SUBARU

March 12, 2012
Ref. No.: GR12-014

**Re: Part 573 Noncompliance Information Report:
Rear Center Seat Automatic Locking Retractor (ALR) on certain 2009-2012 model year Subaru
Forester Vehicles**

Noncompliance Information Report (49 CFR Part 573.6)

<Affected Center Seat Belts of Rear Seat>

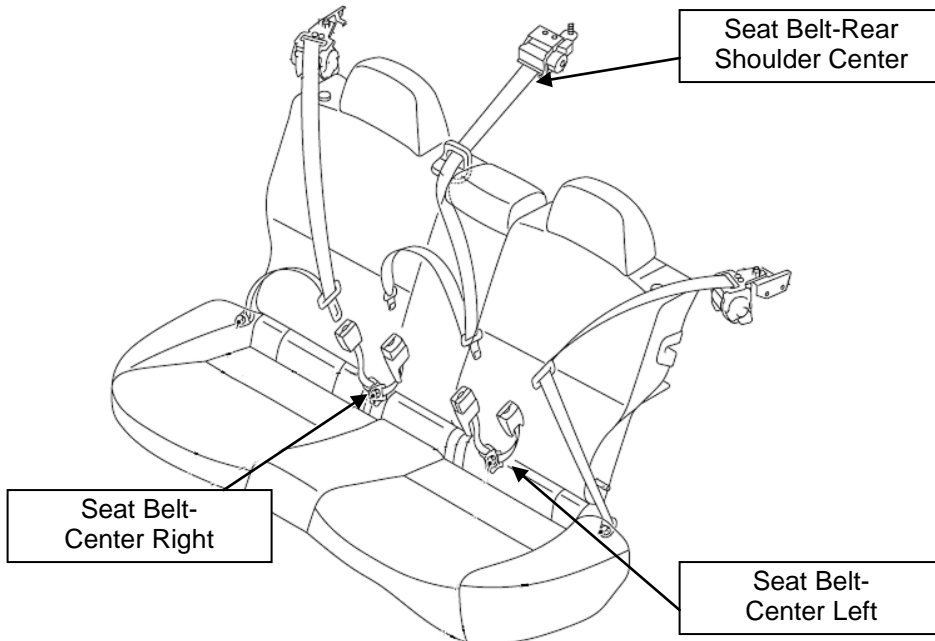
Subaru has determined that the seatbelt assemblies located in the rear center seating position of certain 2009 through 2012 model year Forester vehicles do not meet the lockability requirements prescribed under S7.1.1.5(a) and S7.1.1.5(c) of FMVSS No. 208, "Occupant Crash Protection." Specifically, depending on the shape and size of the CRS being installed, the ALR might not activate (i.e. lock), which could prevent the CRS from being tightly secured to the vehicle.

This noncompliance determination only applies to the rear center seating position (i.e. the ALRs located at the front passenger and rear outboard seating positions are not affected).

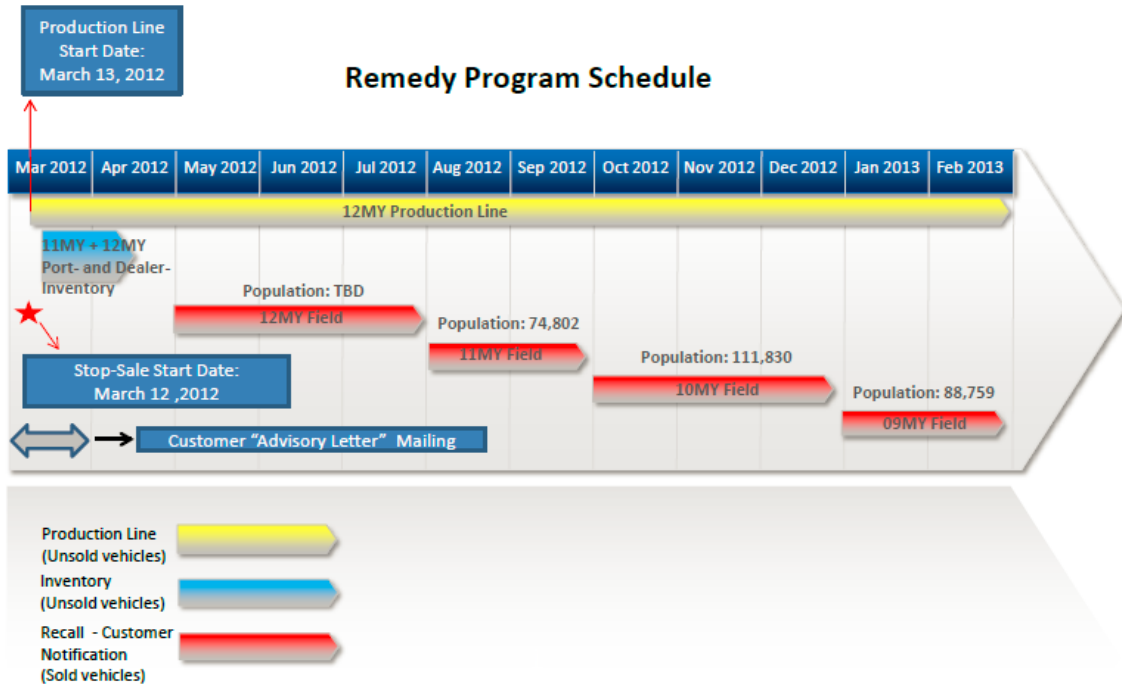
Due to production constraints of the supplier having to manufacture large quantities of replacement parts for the following: (1) Production line, (2) Port- and dealer- inventory, and (3) Customer vehicles, the remedy will be launched in a phased approach as illustrated in the chart below:

(i)-(ii) Subaru of America, Inc. expects to notify U.S. dealers within 30 days of this report. The remedy plan for unsold vehicles in inventory calls for dealers to replace the rear center seat belt assembly with a new one having a shorter belt length and modified Automatic Locking Retractor (ALR) gears. An alternative plan is being taken under consideration to remedy previously sold vehicles. If such a plan is implemented, NHTSA will be advised in advance of a field action by the end of April.
